Historical Architectural Review Board COA Preliminary Review Sheet

HDC-2025-00017

Address: 627 Liberty Street

Proposal: Window replacement, front door replacement, installation of rear dormer, parking pad, and fence.

Existing Front Elevation (Applicant)

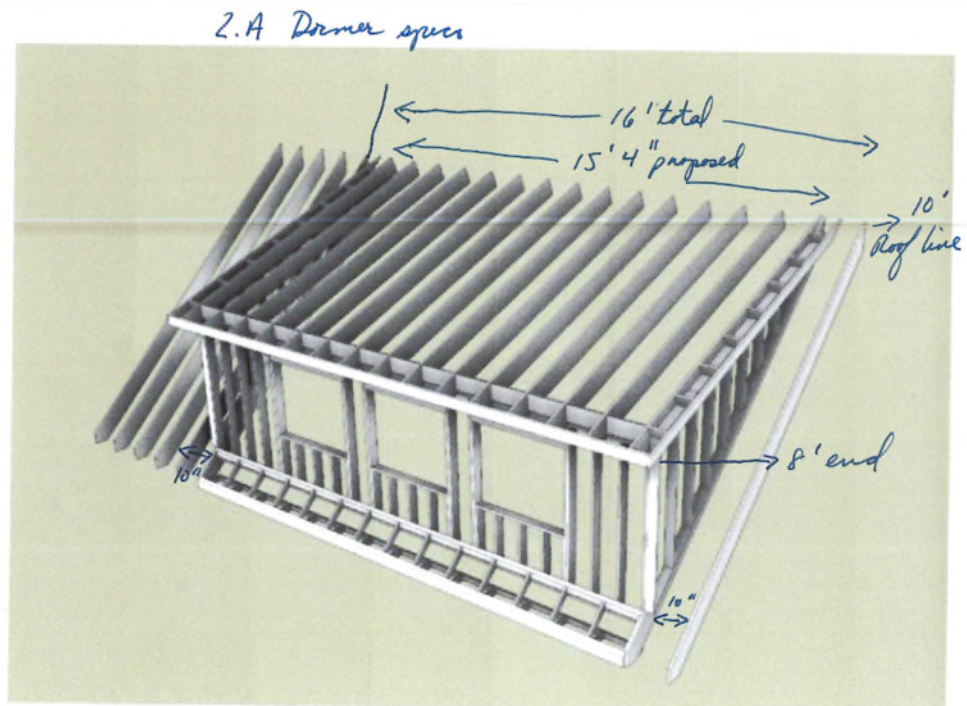
- **Four Front Window Replacement:** While aluminum clad wood is an appropriate material for replacement windows, it would be helpful to review evidence that the current windows require replacement and cannot be repaired. From available imagery it appears that the windows may be original and are in a two-over-two

configuration. If windows are to be replaced and not repaired, replacement windows are to match the original as closely as possible in material, size, type, operation, profile, and appearance.

- **Four Front Window Replacement:** More information regarding the existing condition of the windows would be helpful to understand if the windows are beyond repair.

Example of similar intended shed dormers (Applicant)

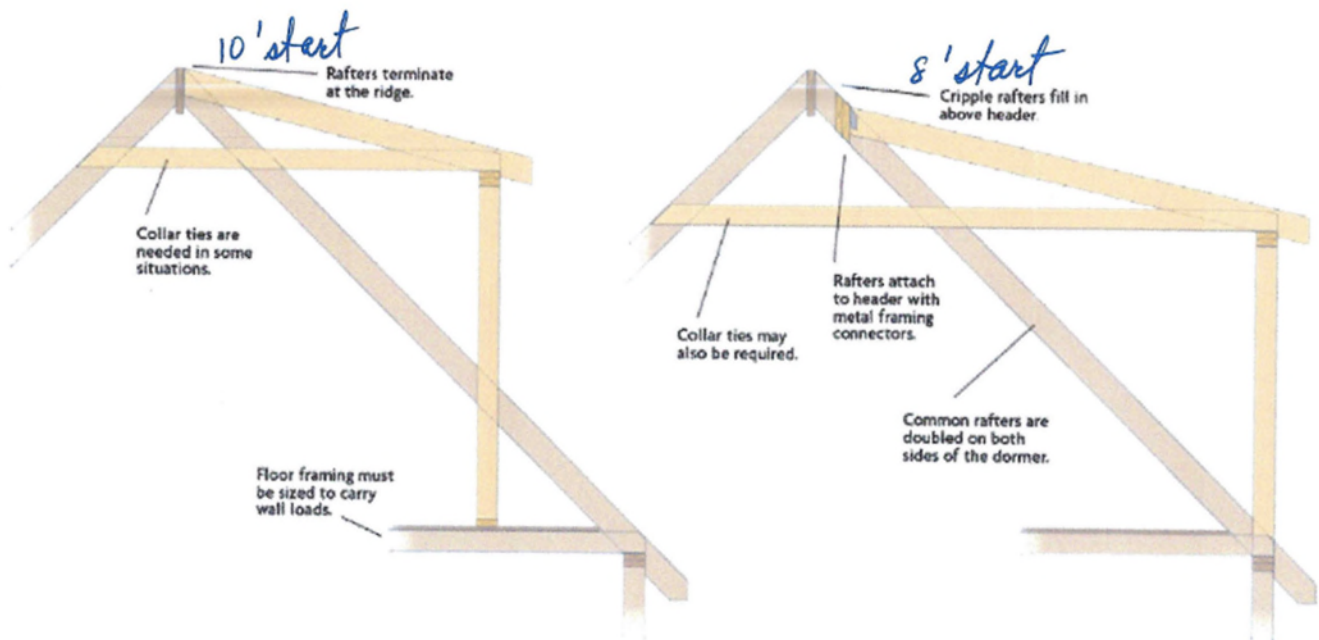
- **New Rear Dormer:** Staff reference 4.1.9, “dormer additions should not overwhelm the historic roof and should be scaled to preserve the predominance of the original roof form. New dormers are inappropriately large if they span from end to end of the original roof or if they reach from eave to ridge, or if they occupy the majority of the roof slope’s area. New dormers on primary façade are rarely appropriate” and 4.1.26 “Design new dormers to be compatible with the existing architectural style and window pattern of the main building. Locate new dormers on rear or side roof slopes to reduce visibility.”

- A dormer addition at the rear of the building is an appropriate location. There would be some visibility from Park Street, and from Pratt Street at the rear, but may not be highly visible.

- The proposed dormer does occupy a majority of the rear roof. It would be helpful to understand if it is possible to further reduce the overall width of the dormer, understanding that an existing interior stair is a limiting factor.

- The proposal indicates 2-4 windows in the dormer. In keeping with the rhythm of the building, it would be appropriate to retain one or two windows.
 - The proposed half round gutters and downspouts are appropriate. Per 3.1.42, paint gutters and downspouts to blend in with the building exterior.

- **New Rear Dormer:** As proposed, the dormer occupies a majority of the rear roof. It would be helpful to understand if the scale of the dormer can be reduced. That discussion will help inform the appropriate approach to fenestration.
